Monitoring Report – Year 5
FINAL VERSION
Edwards-Johnson Mitigation Project
Calendar Year of Data Collection: 2022

NCDEQ DMS Project Identification # 97080
NCDEQ DMS Contract # 6825
Neuse River Basin (Cataloging Unit 03020201)
USACE Action ID Number: SAW-2016-00883
NCDEQ DWR Project # 2016-0404 V2
Johnston County, NC
Contracted Under RFP # 16-006477
Data Collection Period: September 2022
Submission Date: November 30th, 2022

RE: WLS Responses to NCDEQ DMS Review Comments for Task 11 Draft Monitoring Report Year 5 for the Edwards-Johnson Mitigation Project, NCDEQ DMS Full-Delivery Project ID #97080, Contract #006825, Neuse River Basin, Cataloging Unit 03020201, Johnston County, NC

Project Name	Edwards-Johnson Mitigation Project
Project ID	97080
Reach ID	R3
Cross Section ID	XS-6
Field Crew	K. Obermiller, C. Durham

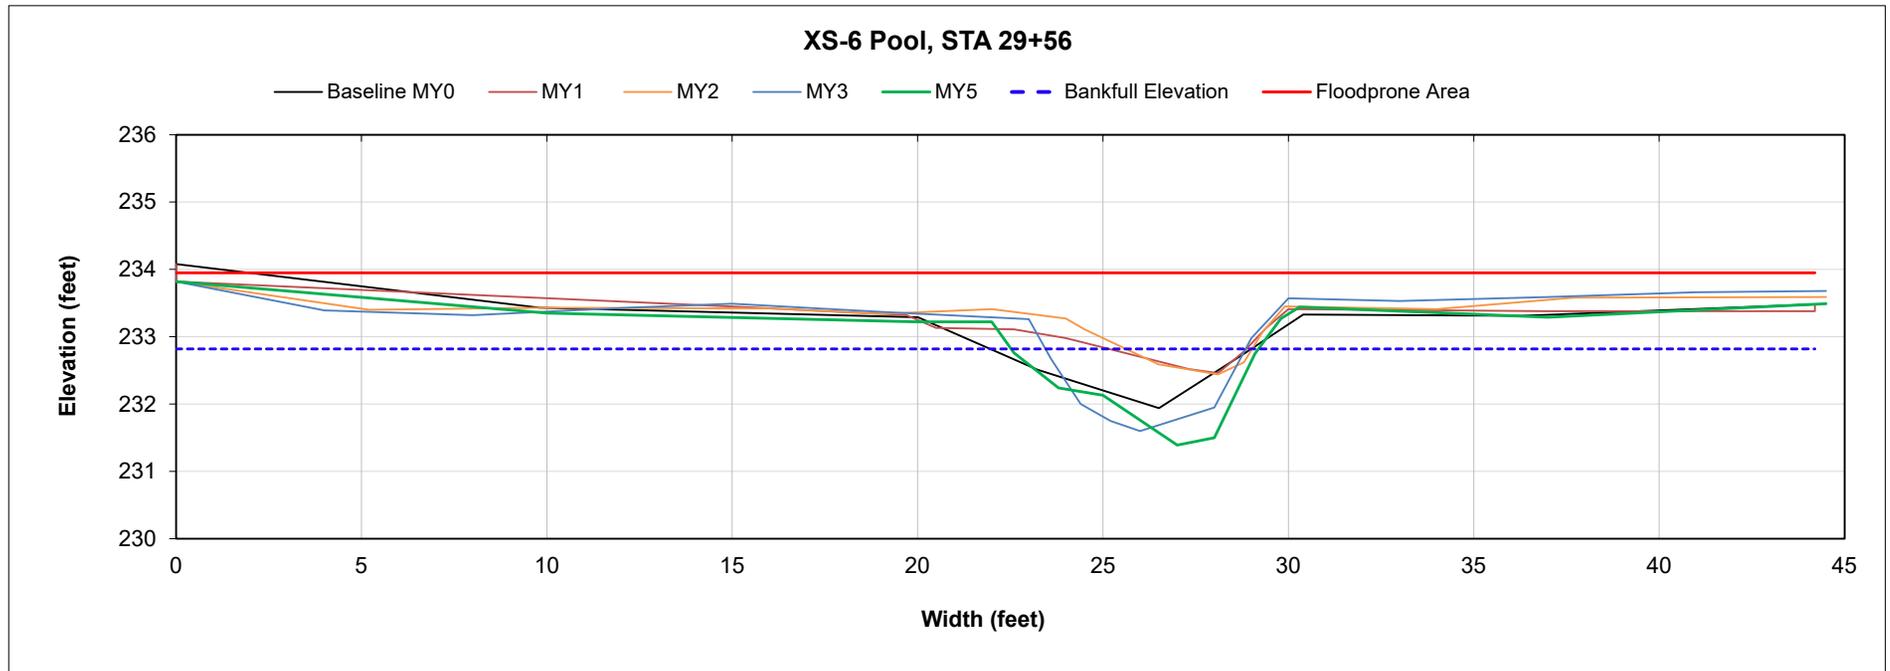
- 4. DMS Comment: Section 5.2 (p.7) and Figure 2 geomorphic tables and MY5 Cross-sections: The 2016 guidance establishes that BHR should not exceed 1.2 or 10% change per year at any measured riffles, but this does not apply to pool cross-sections. Suggest removing BHR and % change BHR from riffle tables.**

Consider also revising narrative on p. 7 referring to these changes in pool xs-6, which appear to be natural geomorphologic processes for this site. It may also be relevant to explain that xs-7 is headwater, and therefore some of the standard geomorphology measurements may not be relevant. WLS Response: WLS agrees with the 2016 guidance that only riffle BHRs and associated changes above 10 percent are relevant. Language on page seven was updated to remove pool cross-sections and corresponding BHRs. BHR for pools was removed from riffle tables.
